**DOCKET ITEM #7**

***Development Special Use Permit with Site Plan #2007-0035  
Mixed Use Office/Retail– 2903 Mount Vernon Avenue***

**DSUP #2007-0035**

## **I. EXECUTIVE SUMMARY**

Figure 2: Color South Elevation

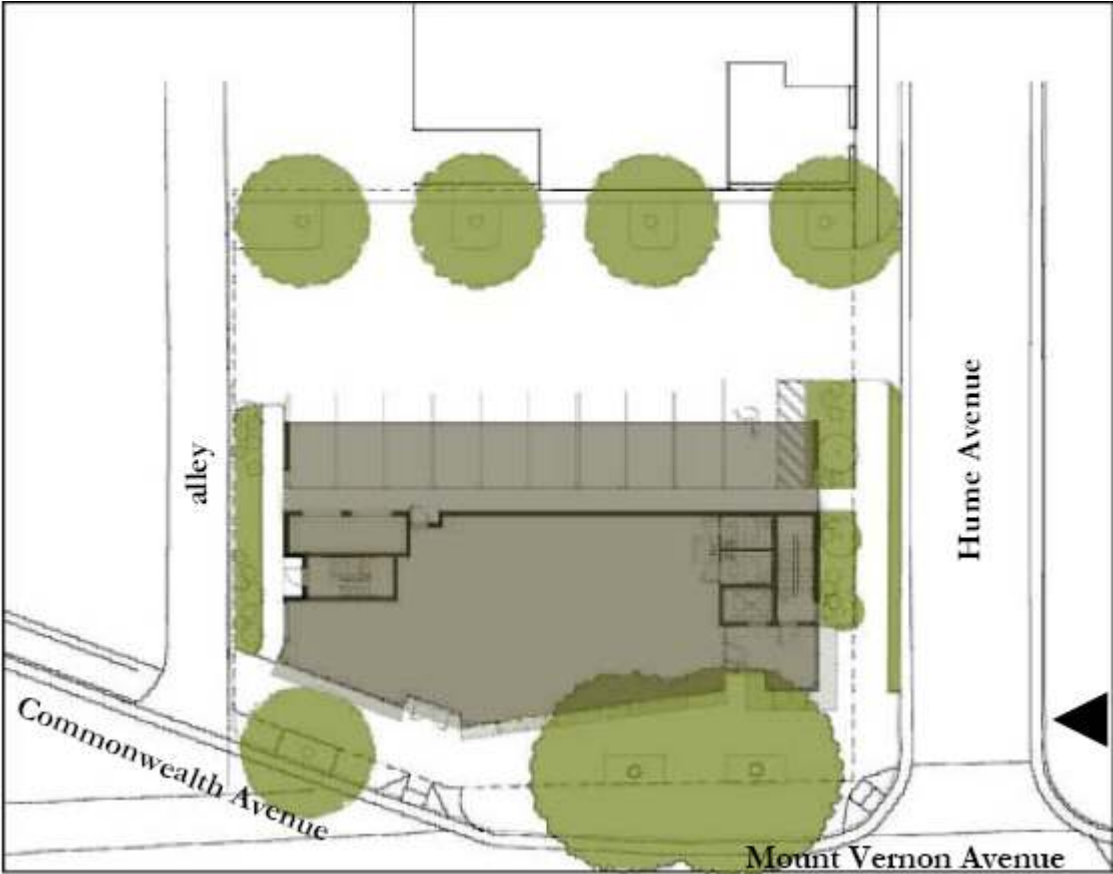
2. The applicant shall provide the following building refinements to the satisfaction of the Director of P&Z:
  - a. Wrap the decorative banding at the windows around all corners, terminating at the stucco wall sections on the sides and the glass hyphens on the Mount Vernon Avenue façade.

- e. Building colors shall be determined at final site plan in coordination with the Director of P&Z.
  - f. Any changes to the building materials listed on the approved preliminary site plan shall be subject to the approval of the Director of P&Z.

- g. Color architectural elevations (front, side and rear) shall be submitted with the final site plan.
  - h. Final refinements to the design and materials shall be revised prior to the release of the final site plan to the satisfaction of the Director of P&Z.

Figure 3: Site Plan

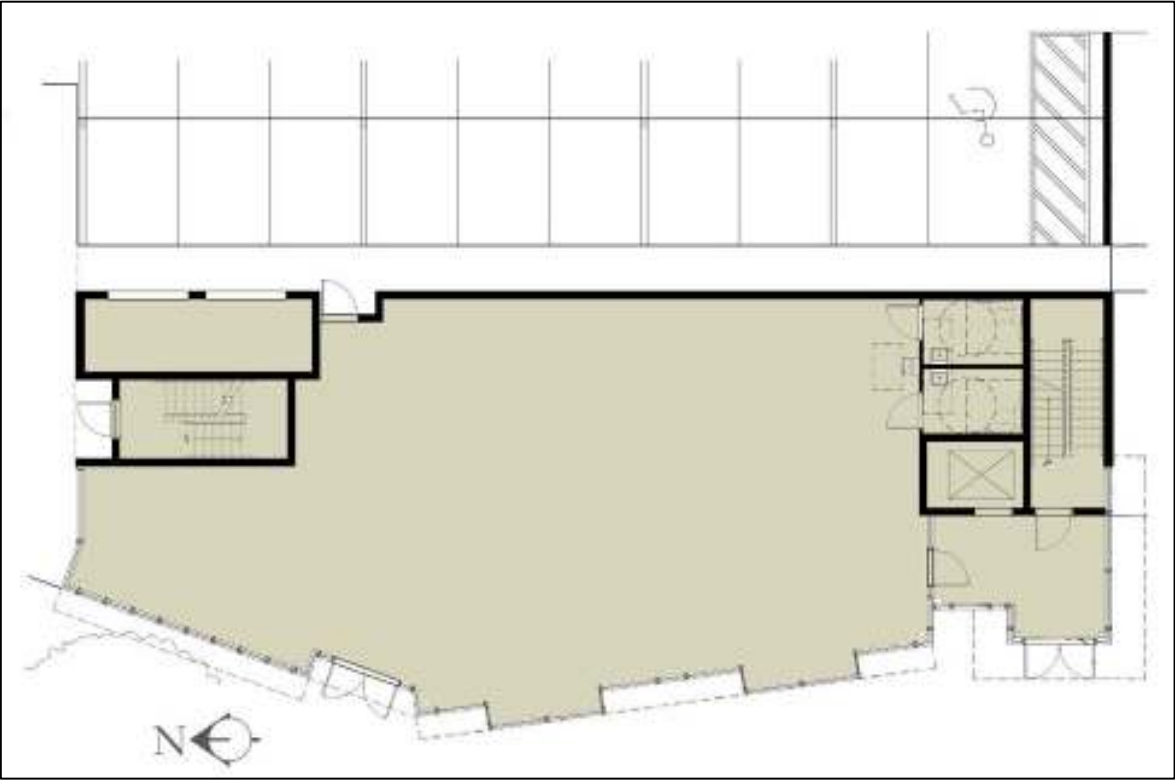
- a. Extend proposed planting area on the north side of the building, adjacent to the alley, to the rear parking lot.
  - b. Proposed planting area at north side adjacent to alley shall be pulled back in line with the building.

- c. Uni-décor pavers shall be wrapped around the building on the Hume Avenue side as far as the landscaped planter (approximately 10 ft.), at which point the sidewalk shall be concrete.

24. The applicant shall replace the concrete pavement in the portion of the alley adjacent to their site, from Commonwealth Avenue to the rear property line, to the satisfaction of the Directors of P&Z and T&ES. The slopes shall be maintained to provide positive storm water drainage through the alley. The alley width shall be maintained at ten feet.. (T&ES) (P&Z)

25. The applicant shall provide bollards at the north side of the alley to protect the residential fence, to the satisfaction of the Directors of P&Z and T&ES.
